EarthTech Earth Tech (Canada) Inc. Winnipeg, Manitoba 204.477.5381		
06/07/10	21-2006 ADDENDUM 8	BL
DATE	REVISION	APP.

THE CITY OF WINNIPEG
Winnipeg WATER AND WASTE DEPARTMENT
 WEWPCC - BIOLOGICAL NUTRIENT REMOVAL UPGRADE

TYPICAL INSTRUMENT LOOP DIAGRAM
 FIELD MOUNTED PROCESS SWITCH

DRAWING NO.
 ILD-05

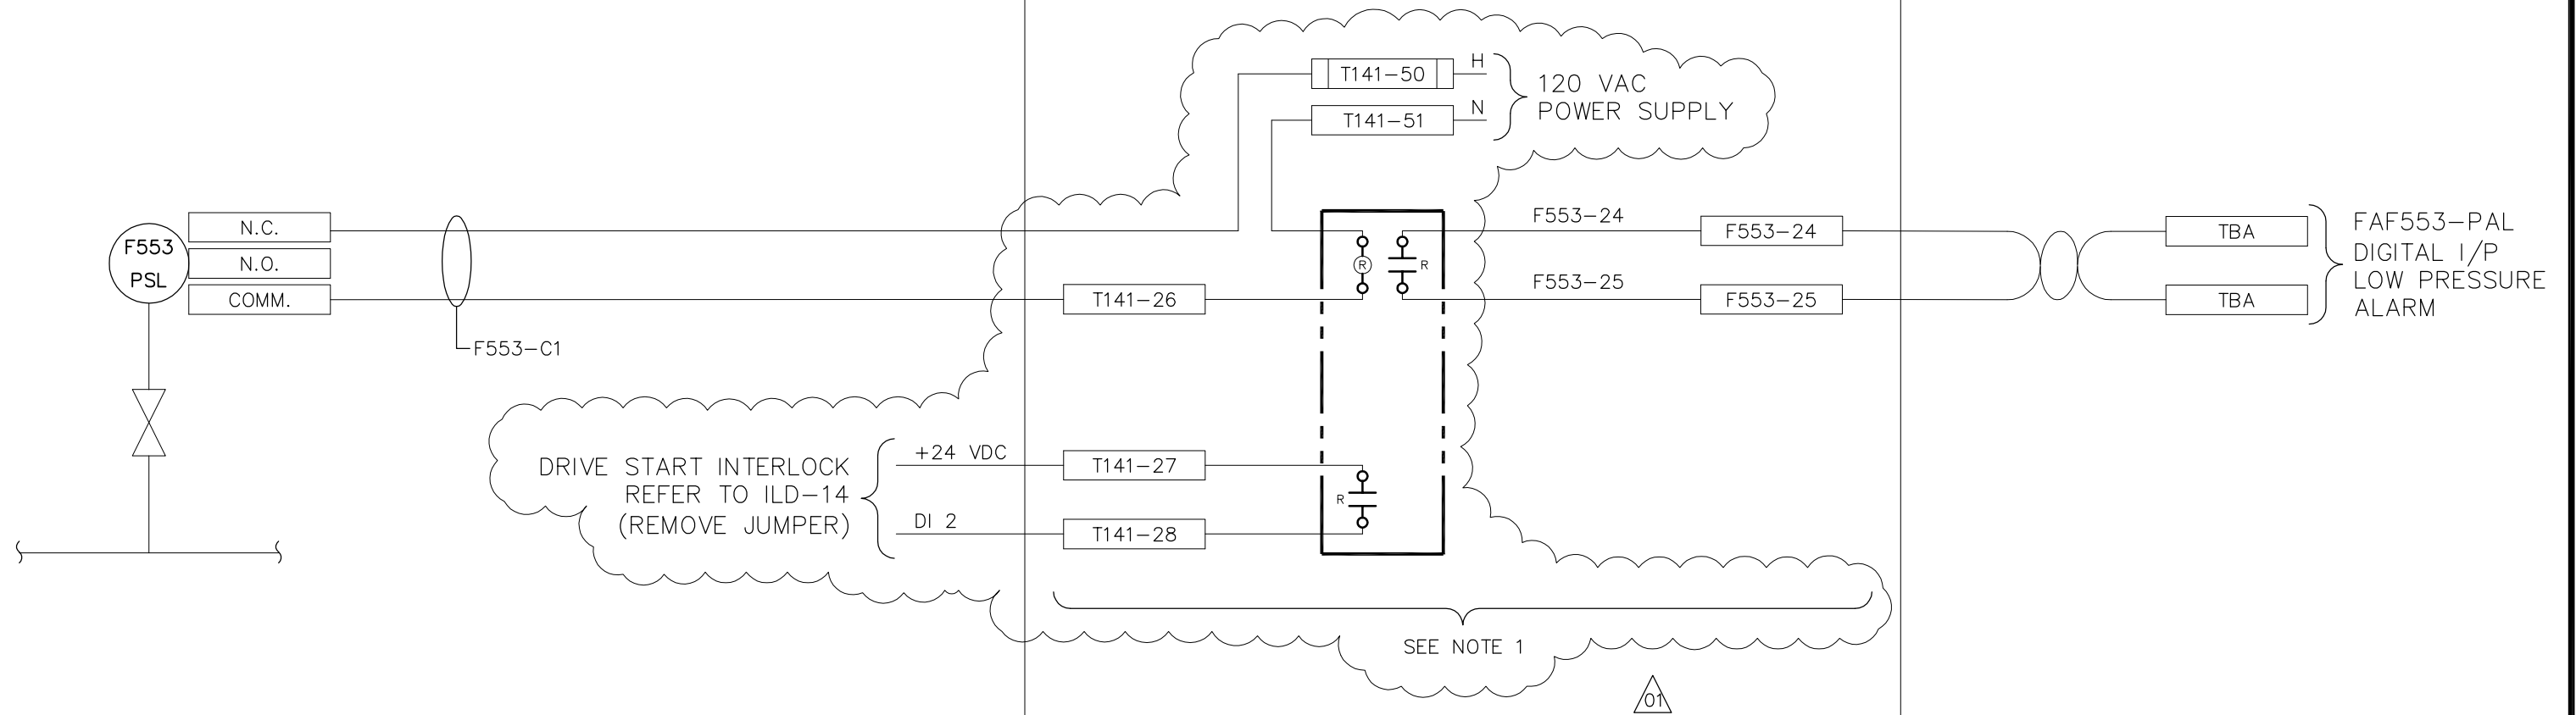
NOTE:
 1. INTERPOSING RELAY IS ONLY REQUIRED FOR T141-FSL, T142-FSL, T143-FSL, AND T444-FSL.
